# UNITED STATES PATENT AND TRADEMARK OFFICE

APPLICATION NO.	FILING DATE	FIRST NAMED INVENTOR	ATTORNEY DOCKET NO.	CONFIRMATION NO.
10/028,419	12/21/2001	Joseph Vanniasinkam	M-9340 US	3557
7590	12/23/2004		EXAMINER	
Finnegan, Henderson, Farabow Garrett & Dunner, L.L.P. 1300 i Street NW Washington, DC 20005-3315				KIANNI, KAVEH C
		ART UNIT		PAPER NUMBER
		2883

<b>Office Action Summary</b>	<b>Application No.</b>	<b>Applicant(s)</b>	
	10/028,419	VANNIASINKAM ET AL.	
	<b>Examiner</b>	<b>Art Unit</b>	
	K. Cyrus Kianni	2883

## DETAILED ACTION

U.S. Patent Jun. 24, 2003 Sheet 5 of 34 US 6,583,934 B2

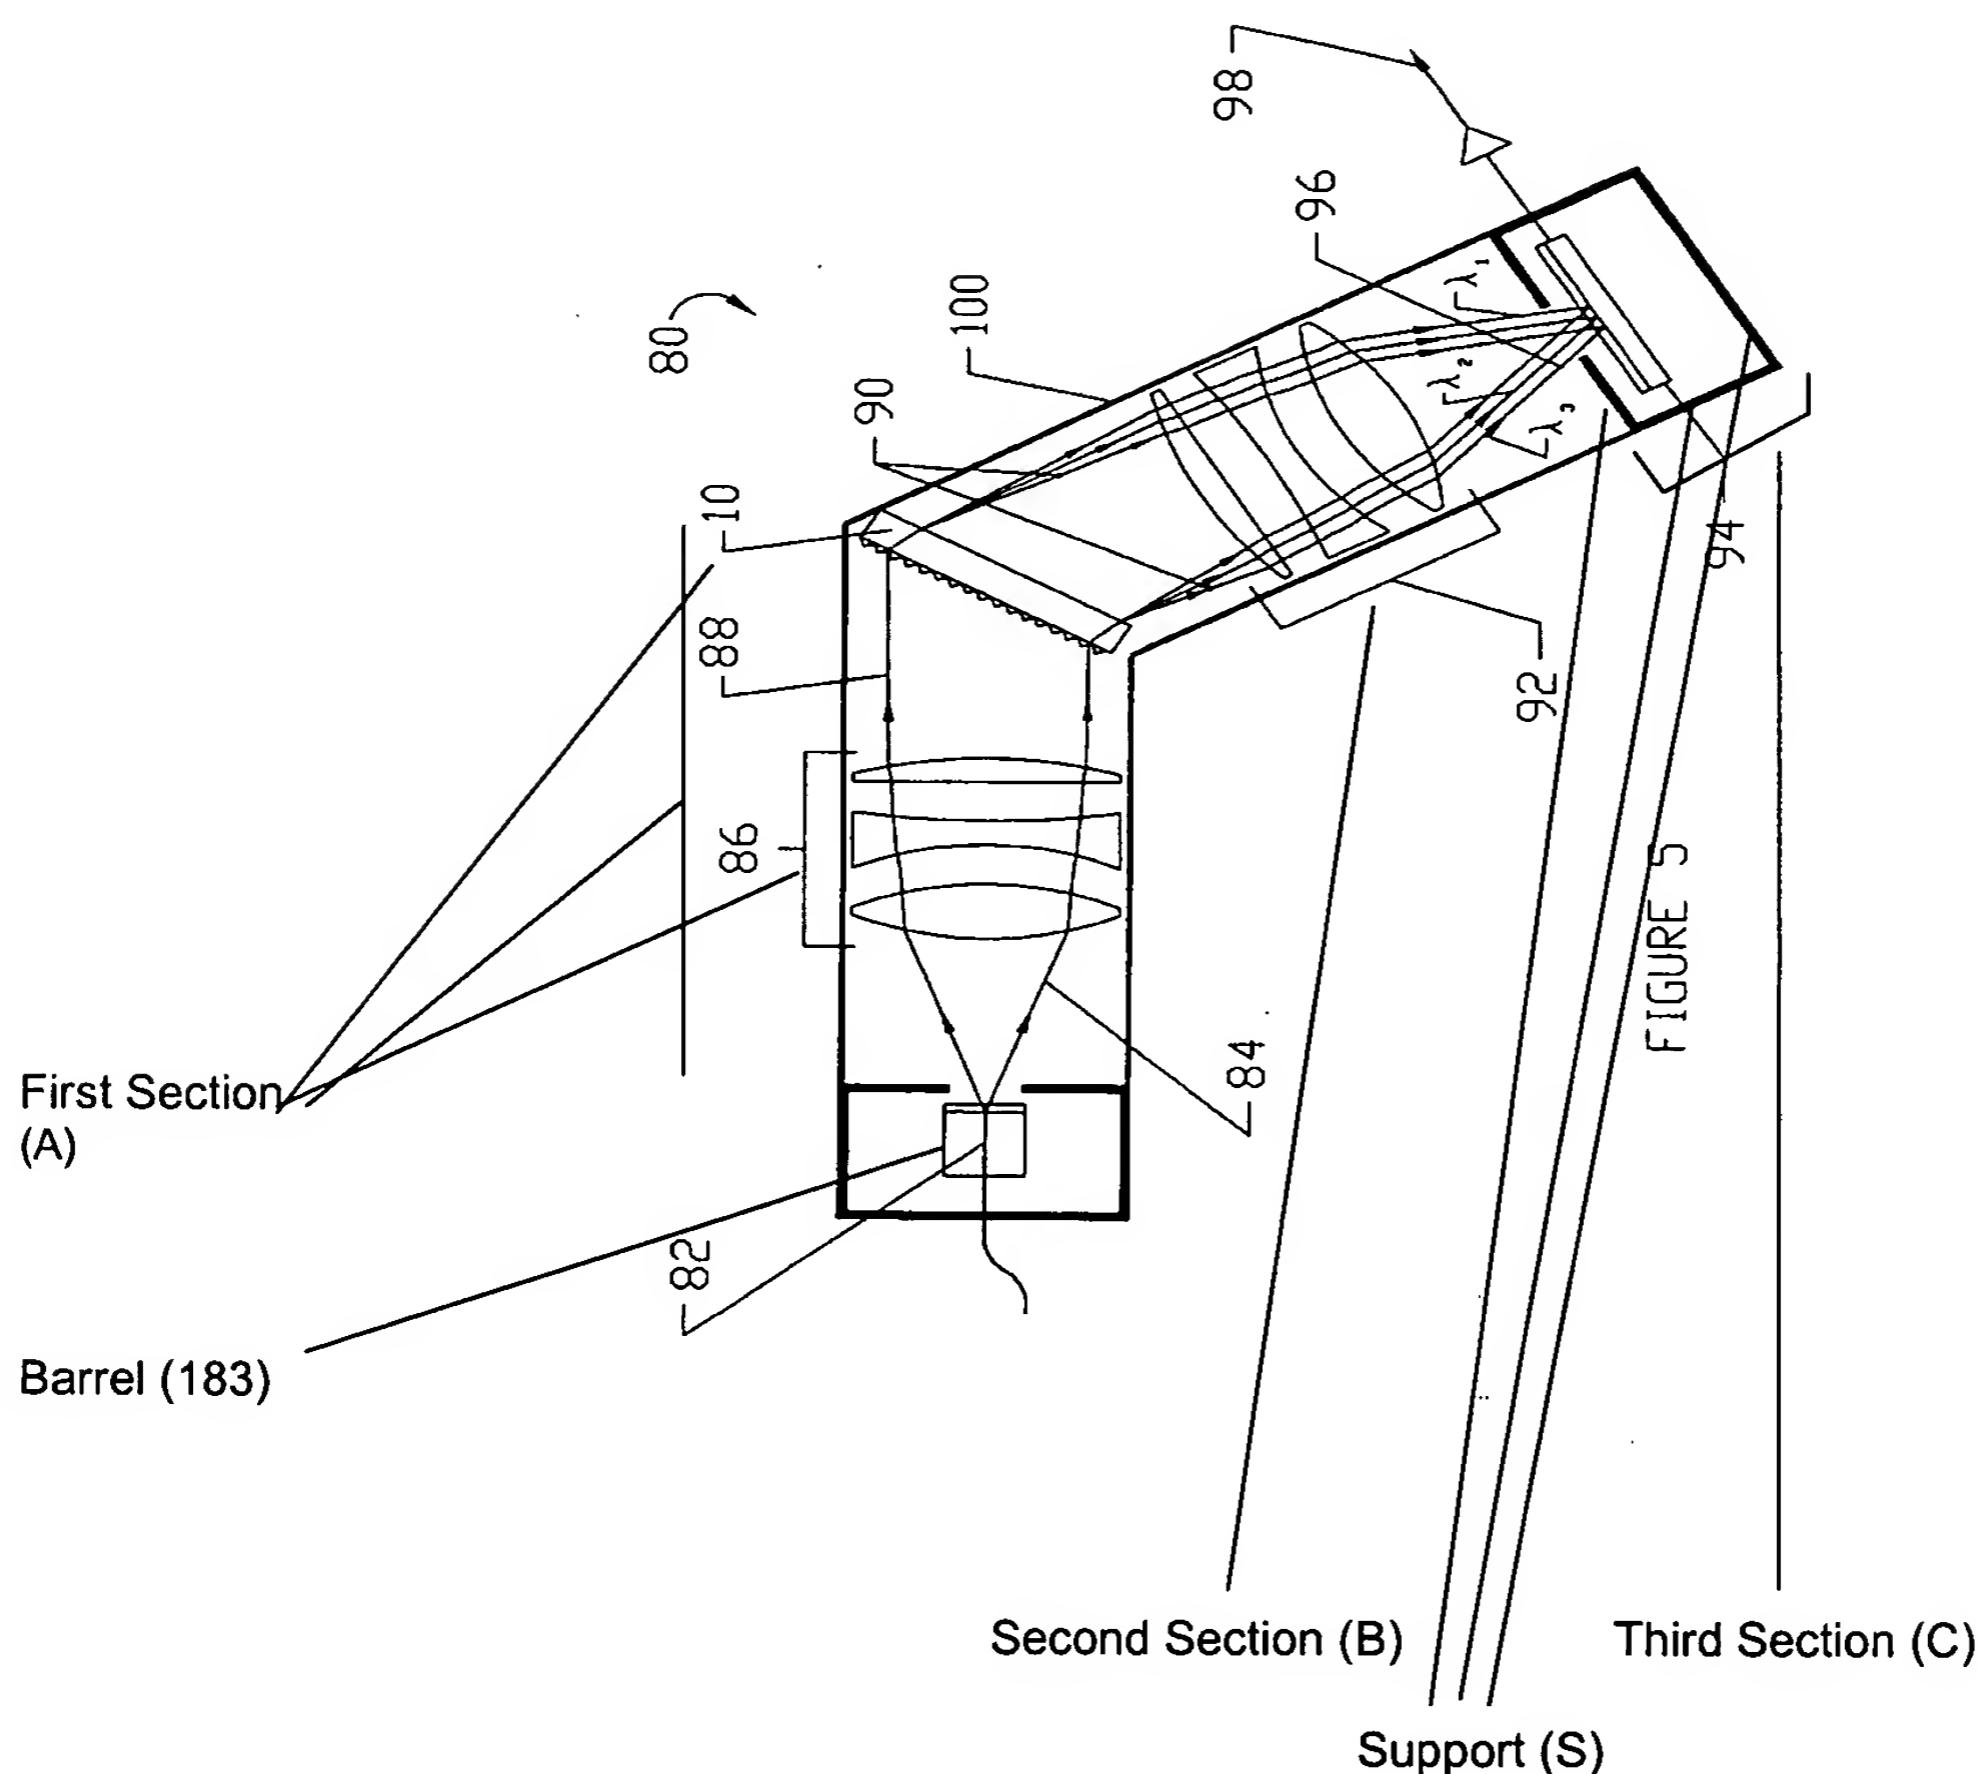
Regarding claims 1-6 and 12-13, Kramer teaches a monitoring device (shown in at least figure 5, see above figure), comprising:

a first section A capable of receiving a WDM beam (see fig 5, item first section A containing lens assembly 86 and grating 10 for receives WDM beam via fiber 82; see also col. 13, lines 48-52),  
a diffraction grating 10 integrally formed with the first section A (shown in fig. 5, item diffraction grating 10 integrally formed in the first section via housing 100), the WDM beam 88 being directed onto the internal surface of the diffraction grating 10 (shown in fig. 5, item 10 receives WDM beam), the diffraction grating/means 10 providing angularly separated beams  $\lambda 1..\lambda 3$  on the external surface of the diffraction grating 10;  
a second section B (see second section for collimating and focusing diffracted beam 90) integrally formed with the first section A; and  
a third section C integrally formed with the second section B, the third section C positioned relative to the first section C to receive spatially separated light beams 90 of a selected diffraction order  $\lambda 1..\lambda 3$  from the diffraction grating 10 (shown in fig. 5, item third section C receives spatially separated light beams of a selected diffraction order  $\lambda 1..\lambda 3$  from the diffraction grating 10);

wherein the first section A, the second section B, and the third section C are integrally formed in a single piece (see fig. 5, wherein the first section A, the second section B, and the third section C are integrally formed in a single piece through housing 100);  
Kramer further teaches wherein the reflective surface is coated external to the first section with thin/reflective/gold film to enhance internal reflection of the WDM beam (see col. 10, line 66-col. 11, line 15).

However, Kramer, in the first embodiment, does not specifically teach wherein the above monitor in the preamble is a demultiplexer; a reflective surface coated with a silver/reflective film, integrally formed on the first section that directs the WDM beam received into the first section onto a bottom surface of the diffraction gating; wherein the third section includes a focusing lens that has support around it. Nevertheless, Kramer's monitor device diffracts WDM beam into individual wavelengths and in second embodiment Kramer teaches a reflective surface integrally formed on the first section that directs the WDM beam received into the first section onto a bottom surface of the diffraction gating (see fig. 18 and 19, item reflector 15 and grating 15') that the reflecting surface is coated with a reflecting coating such as gold or aluminum (see col. 9, line 66-col. 11, line 5); Kramer further states that appropriate lens assembly combinations will be apparent to those skilled in the art (see col. 16, 3<sup>rd</sup> parag.). Thus, It is well known to those of ordinary skill in the art that separation of multiplexed light into separate wavelengths known as demultiplexor, and it would have been obvious to a person of ordinary skill in the art when the invention was made to combine different embodiments of Kramer's teachings such as by replacing the grating 10 with that of double grating 250 in which item 15 functions as a reflector and use a silver coating rather than a gold or aluminum, and further, as a matter of design choice, place a lens around the support section S aperture (see above figure) of third section in order to construct a demultiplexing system that includes the above limitations, and since such coating would have essentially the same functional effect and since such demultiplexing

Regarding claims 23, Kramer teaches a monitoring device (shown in at least figure 5, see above), comprising:

means for separating an input light beam 88 into constituent parts  $\lambda 1..\lambda 3$  with an integrally formed component 10 (see fig. 5, above, first section S through grating 10 separates input beam 88 into  $\lambda 1..\lambda 3$ );

means 94 for detecting the constituent parts  $\lambda 1..\lambda 3$  from the integrally formed single piece component 10;

means 100 for aligning the means for separating (see first section S) with the means for detecting 94 (see the housing 100, inherently, aligns the first section S--for separating the input light beam 88 into constituent parts  $\lambda 1..\lambda 3$ —with that of the detector 94; note that this alignment scheme is analogous to the applicant's aligning means—i.e., as stated in the specification parag. 0034 with regard to alignment of the elements/means in figure 2). Regarding Kramer's teachings of demultiplexer the arguments presented in rejection of claim 1 is analogous in rejection of claim 23.

Applicant alleges (page 6, 2<sup>nd</sup> parag.-page 7) that Kramer does not teach integrally forming various components in the first, second and third sections elements such as lens and barrel in a single piece. The examiner responds that Kramer indeed teaches integrally forming various components in the first, second and third sections A-C elements such as lens 86 and barrel 183 in a single piece as shown above in figure 5.
